MADRAS ELEMENTARY SCHOOL AND BUFF ELEMENTARY SCHOOL IMPROVEMENTS

PROJECT NO.: 22140B

ADDENDUM NO. 2

DATE: September 29, 2023

Sheet No.
C2.01

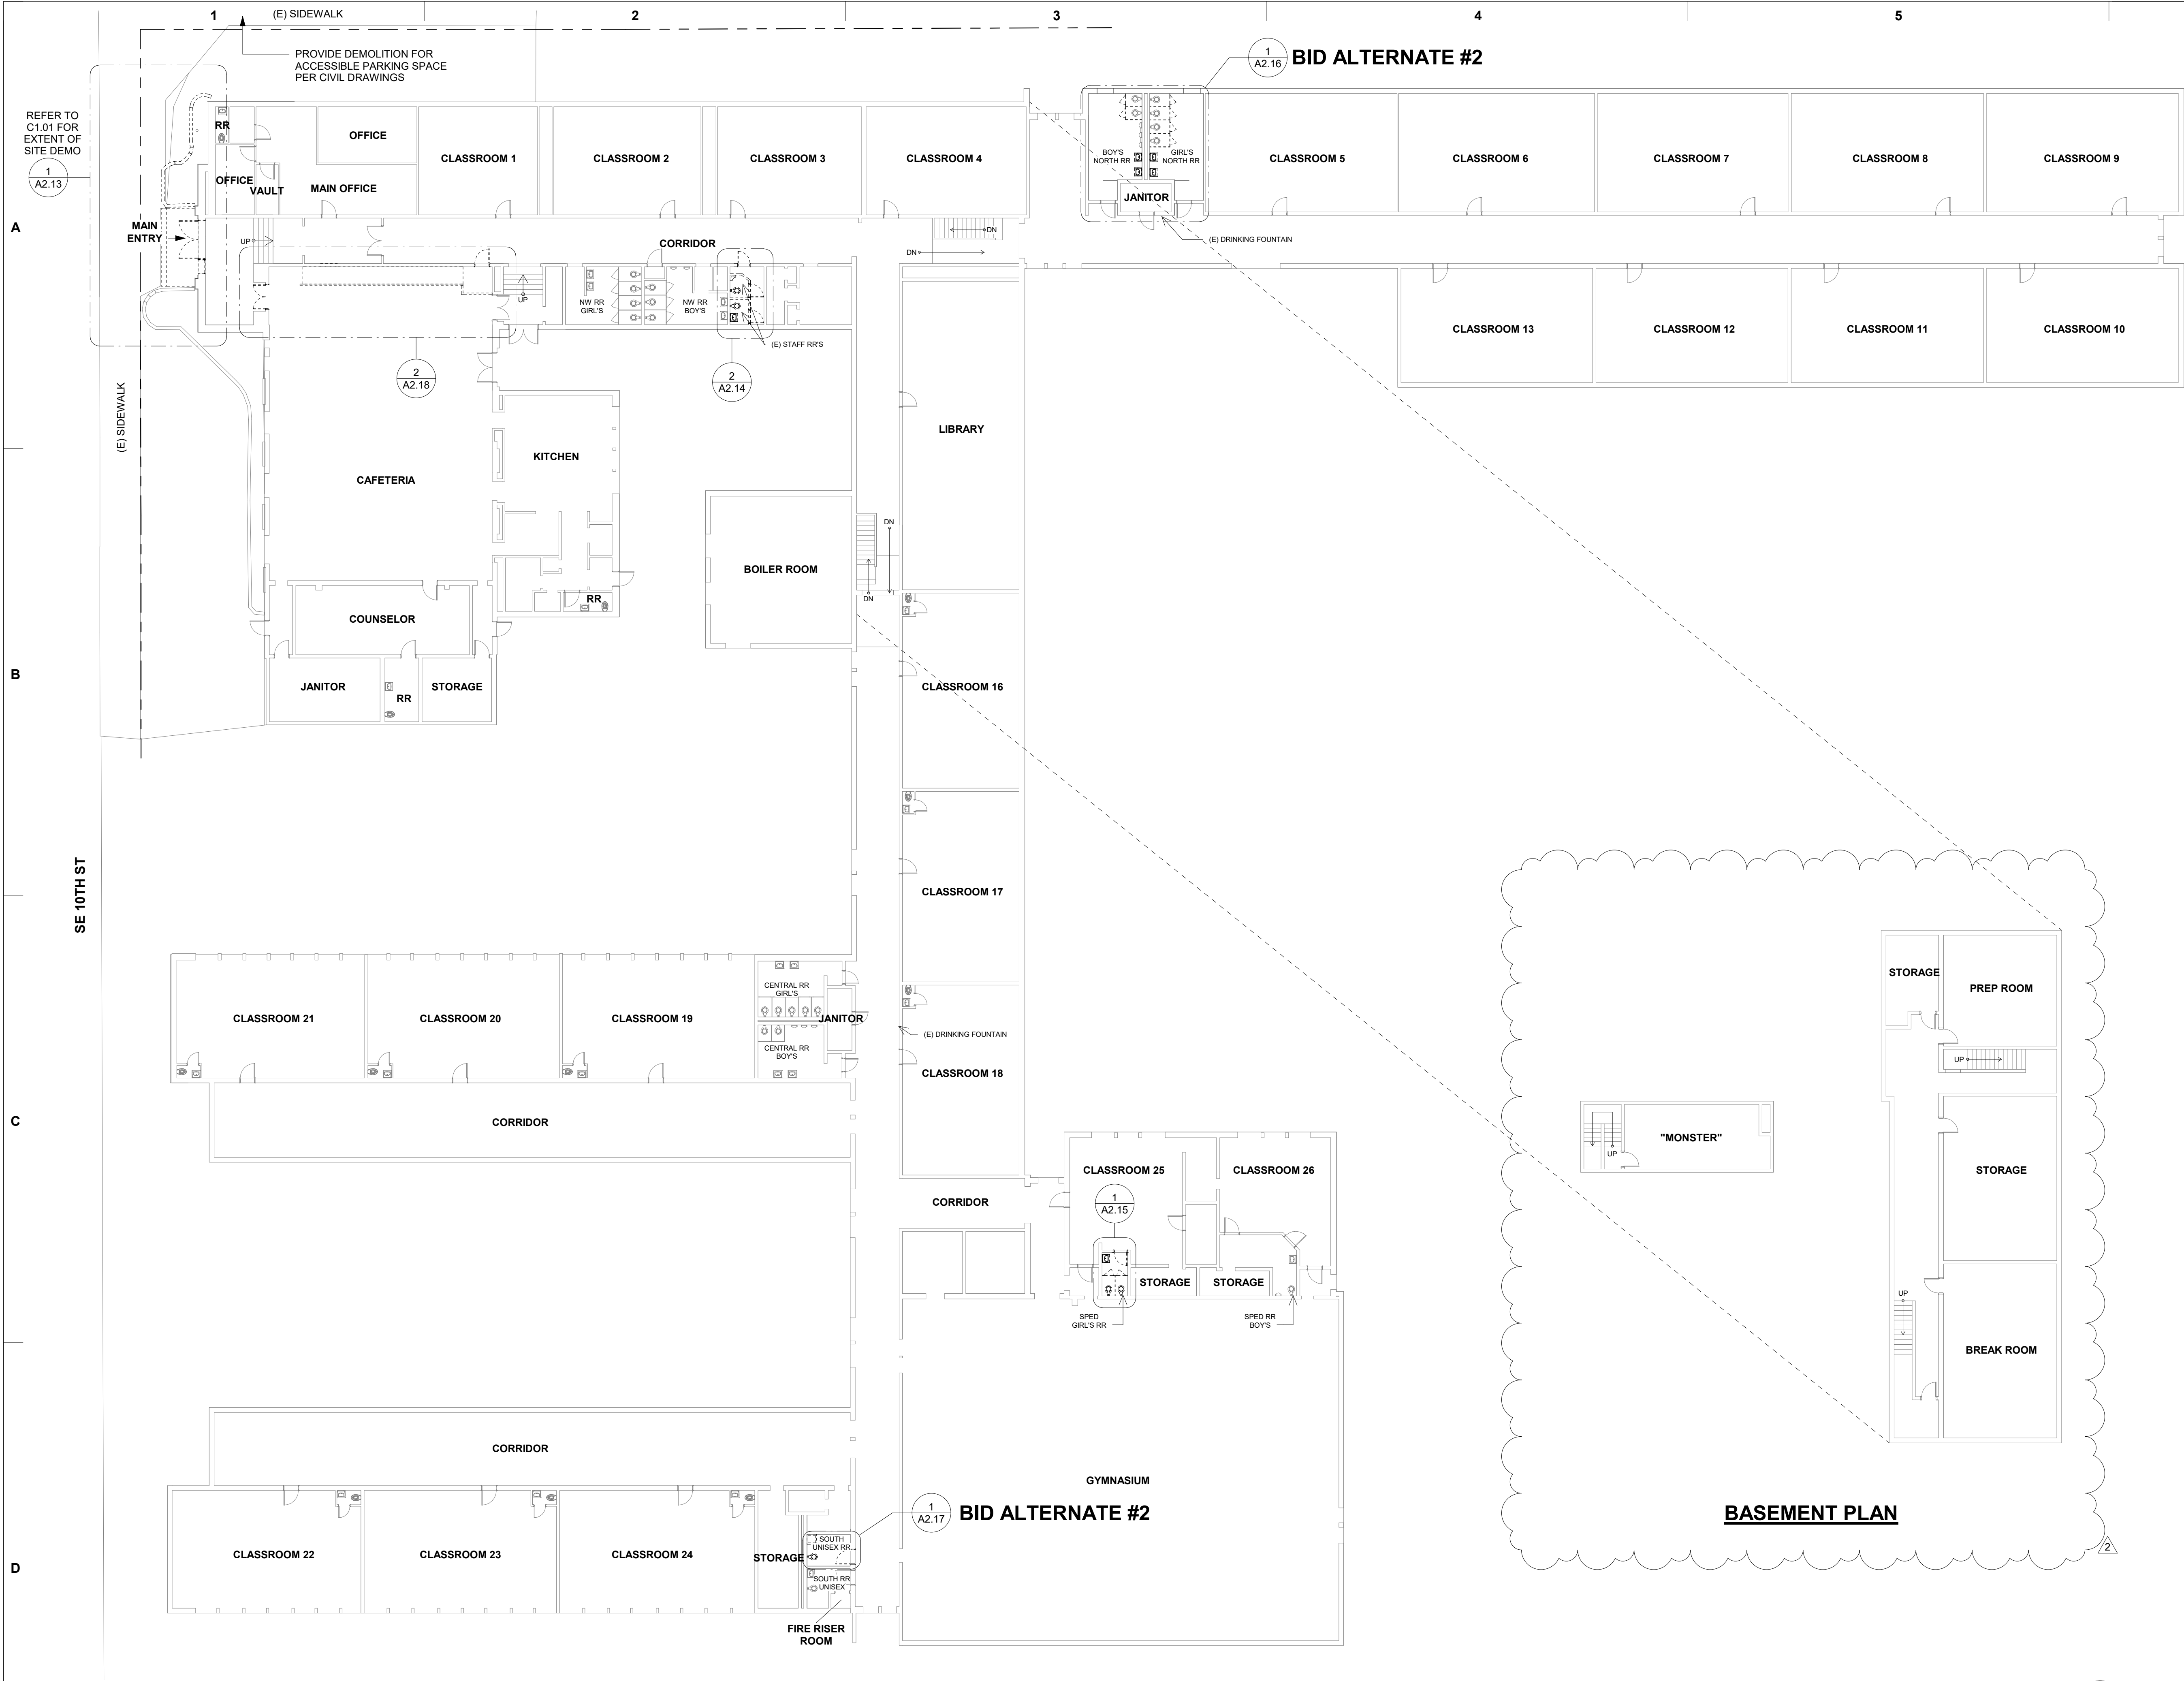
5. Madras ES: Confirm that the Jurisdiction Having Authority will allow the relocation and reuse of the existing poured-in-place concrete catch basin at the revised street corner as shown in the drawings.

- a. Revised Note #9 to show the existing catch basin being removed.
3. C2.01 Grading and Paving Plan
 - a. Revised Note #11 to show new catch basin being installed.

- Civil drawings have been revised to show a new catch basin being installed. The existing catch basin is to be removed.
6. Madras ES: Please provide the location of all existing fire smoke dampers, per OFC all existing or new FSD require the monitoring of the Open and Closed positions of the vanes and not the actuator

- CONSTRUCT TRANSITION PANEL
(PER ODOT DTD DWG RD722, SHEET C3.02)
- INSTALL SALVAGED STOP SIGN W/ STREET SIGNS
(PER COM STD DWG 7-17, SHEET C3.02)
- INSTALL STANDARD CATCH BASIN. EXTEND STORM DRAIN PIPE 2 LF.
(PER ODOT STD DWG RD364, SHEET C3.02)

REFERENCE DEMOLITION PLAN		
Drawing Title:	Date:	Drawn By:
	SEPTEMBER 11, 2023	LCG
	Revised:	Project No.
		22140

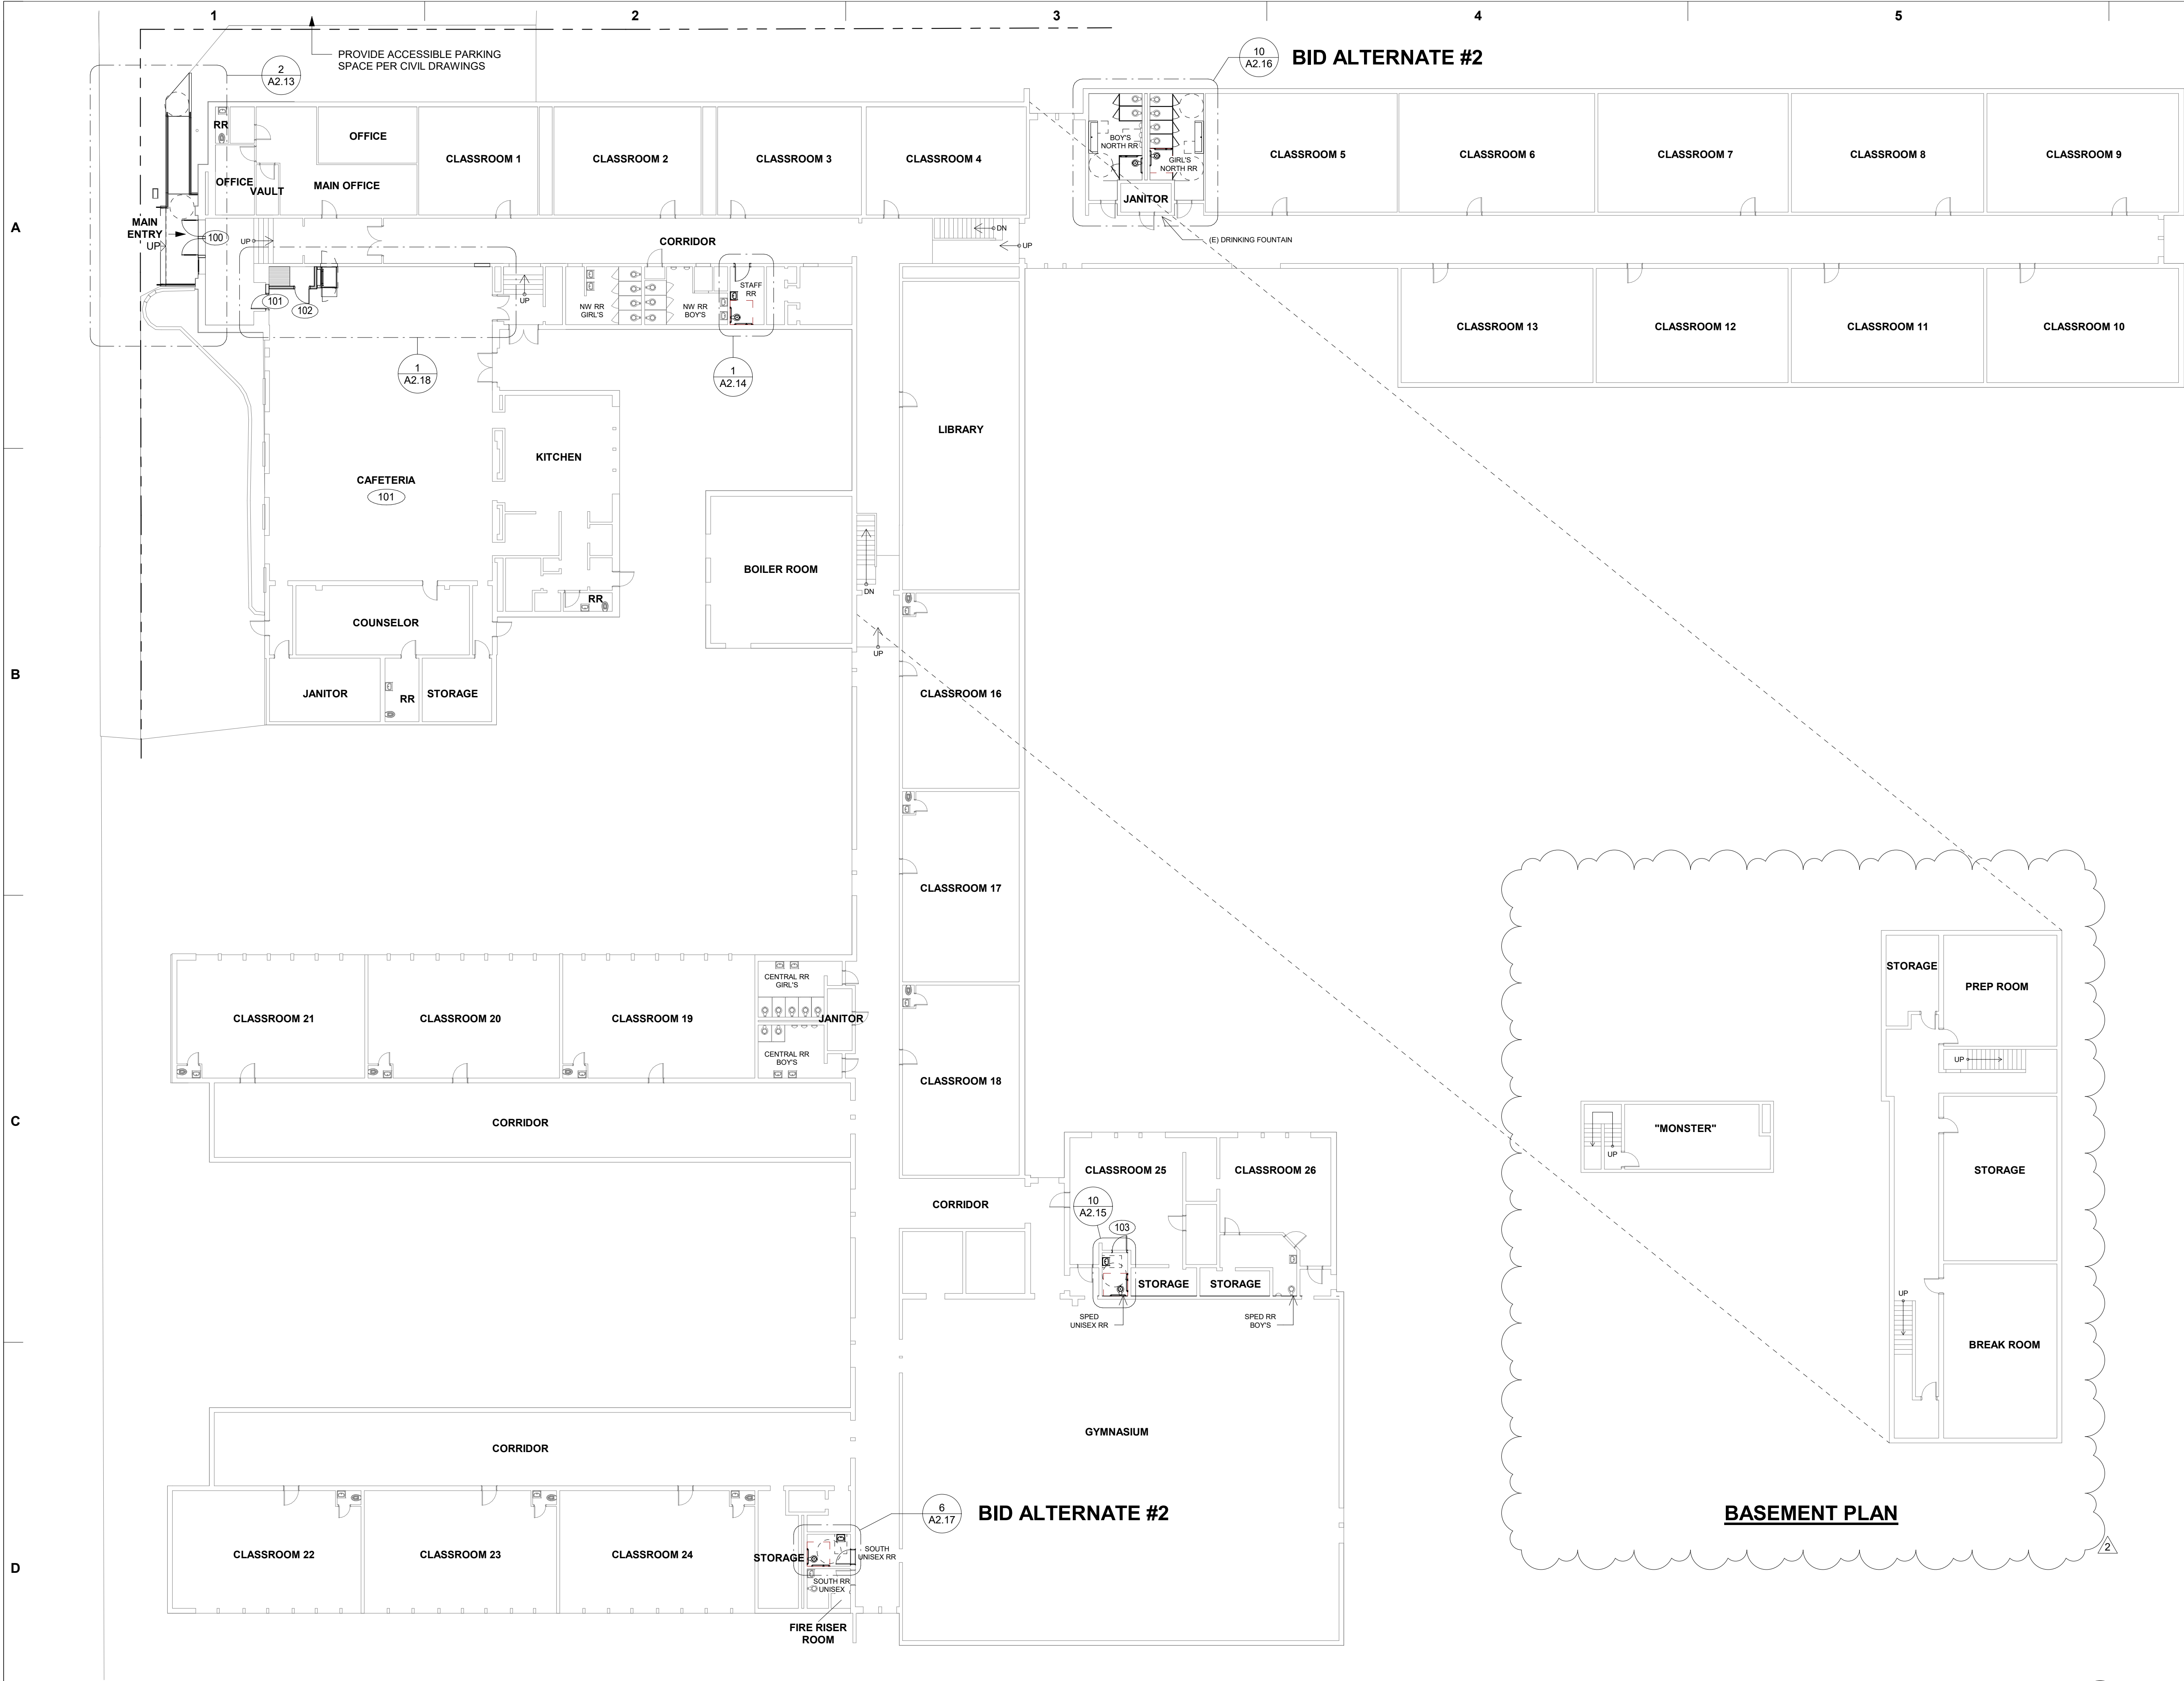
4. A2.11 Reference Demolition Plan
 - a. Basement Plan is now shown.
5. A2.12 Reference Floor Plan
 - a. Basement Plan is now shown.
6. A2.18 Accessible Lift
